BID ADDENDUM NO.1

BEST ROADS MUTUAL WATER COMPANY WATER SYSTEM CONSOLIDATION PROJECT, CALIFORNIA DEPARTMENT OF WATER RESOURCES GRANT AGREEMENT NO 4600015596.

12/12/2024

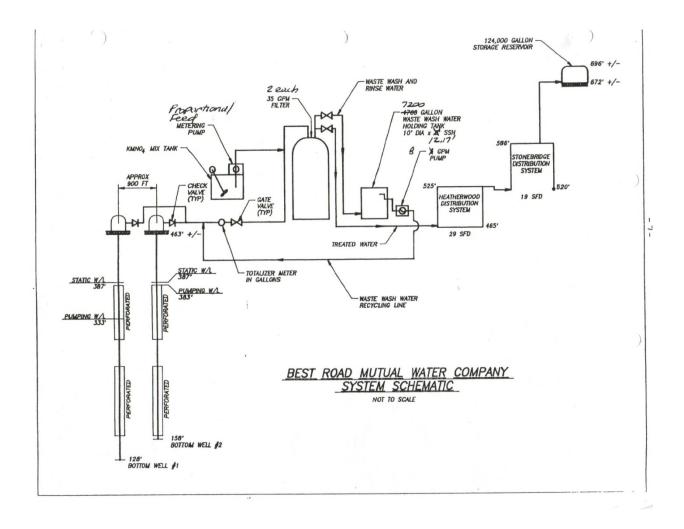
11	12/11/2024	Maggoria Bros.	Can you provide the "Well	Sunnyslope is working to obtain the
		Drilling, Inc.	Completion Reports" for the	Well Completion Reports through San
			wells that are being destroyed?	Benito County Water District or the
				State since Best Road Mutual did not
				have them in their records. They will be
				provided through a separate Addendum.
				A diagram obtained from Best Road
				Mutual showing the well depths is
				included here.
